Bayside Planning Panel

Item No	6.3
Application Type	Residential Flat Building
Application Number	DA-2017/231
Lodgement Date	22 December 2016
Property	10 Loftus Street, Turrella
Owner	Betar Investments Pty Ltd and Verdun 523 Pty Ltd
Applicant	Verdun 523 Pty Ltd
Proposal	Integrated Development - Construction of an eight (8) storey residential flat building comprising 24 units and five (5) levels basement carparking and demolition of existing structures
No. of Submissions	Nil
Cost of Development	\$8,159,574.00
Report by	Patrick White, Town Planner, Creative Planning Solutions Pty Ltd

Planning Assessment Report

Application Number:	DA-2017/231
Date of Receipt:	22 December 2017
Property:	10 Loftus Street, TURRELLA NSW 2205
Owner:	Betar Investments Pty Ltd, Verdun 523 Pty Ltd
Applicant:	Verdun 523 Pty Ltd
Proposal:	Construction of an eight (8) storey residential flat building comprising 24 units, five (5) levels of basement car parking, and demolition of existing structures.
Recommendation:	Refusal
No. of Submissions:	None.
Author:	Patrick Wait – Creative Planning Solutions Pty Limited
Date of Report:	6 November 2017

Figure 6 - Extract of the maximum height of building RLEP2011 map, illustrating height transition from the subject site (P2) to adjoining sites (M) to the low density areas (I)

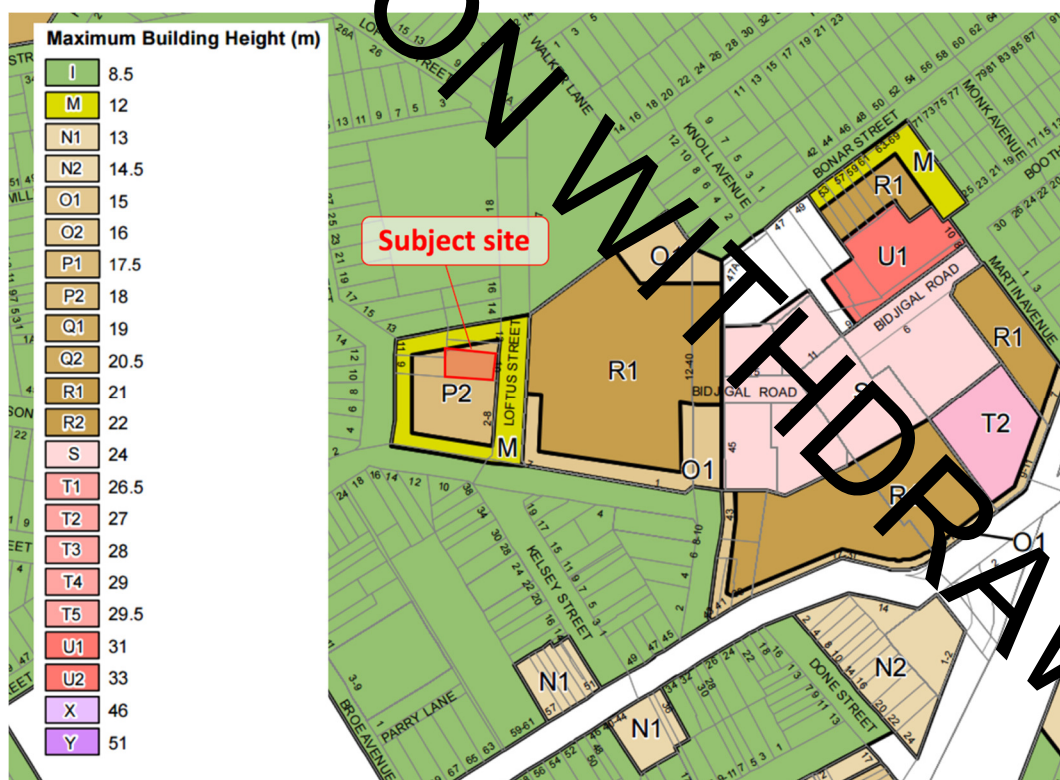
- The proposal does not achieve the objectives of the standard;
- The maximum building height standard ensures an appropriate height transition is provided from the higher density developments towards the east of the subject site, to the low-density developments towards the west and north of the subject site. The proposed height does not support creation of an appropriate transition in built form and land use intensity (refer to **Figure 6**);

- The height exceedance will result in additional land use intensity beyond that which is otherwise envisaged via Council's planning controls;
- The height exceedance will result in adverse impacts to the level of amenity of adjoining low density residential developments; and

For the building height exceedance alone, and the non-support of the submitted clause 4.6 written request, the development cannot be approved.

Figure 7 - Zoning map of local area, illustrating that the site at 12 Loftus Street is adjoining by low density residential zoned land

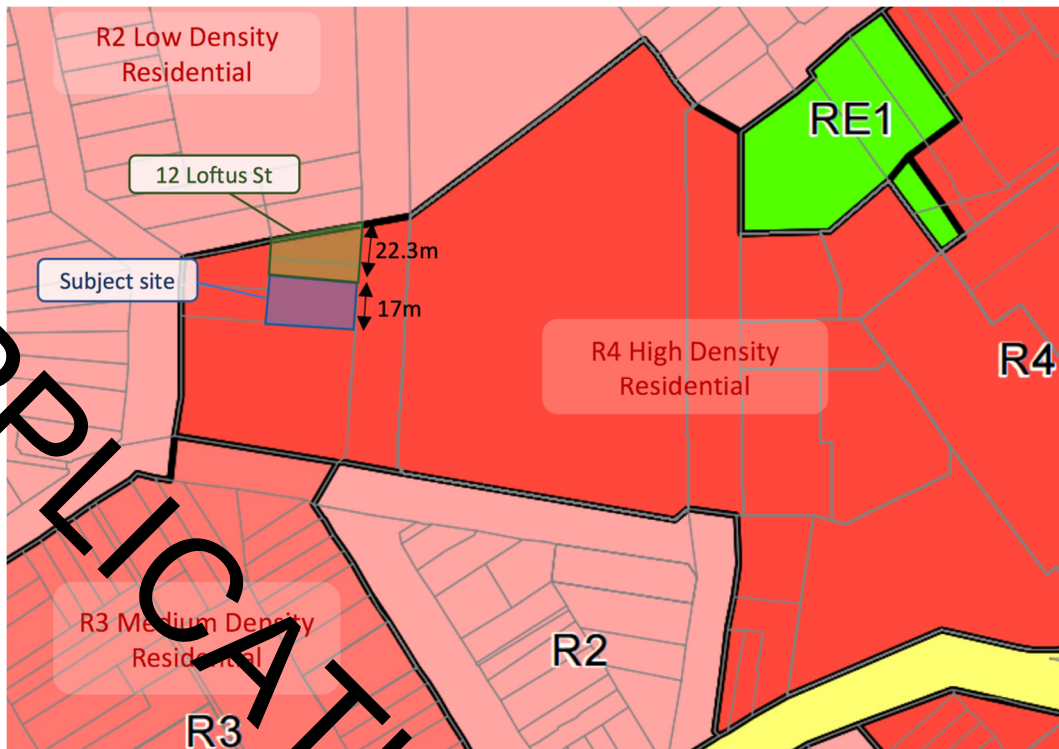
The proposed development would isolate the north adjoining site at 12 Loftus Street. The site at 12 Loftus Street does not exhibit the required 24m frontage width for a residential flat building development pursuant to Section 4.1.9 of the RDCP2011, and is furthermore not adjoined by any other high density residential (R4) zoned land (other than the site which is subject to the proposal). Refer to **Figure 7** for diagrammatic image of local zoning.

The applicant has not demonstrated that reasonable attempts, in accordance with the steps outlined in the site isolation planning principle established in *Karavellas v Sutherland Shire Council* [2004] NSWLEC 251 at 17-19, have been made to acquire this adjoining land. It is noted that Council's Pre-DA letter sent of 1 June 2016, advised such amalgamation to be pursued.
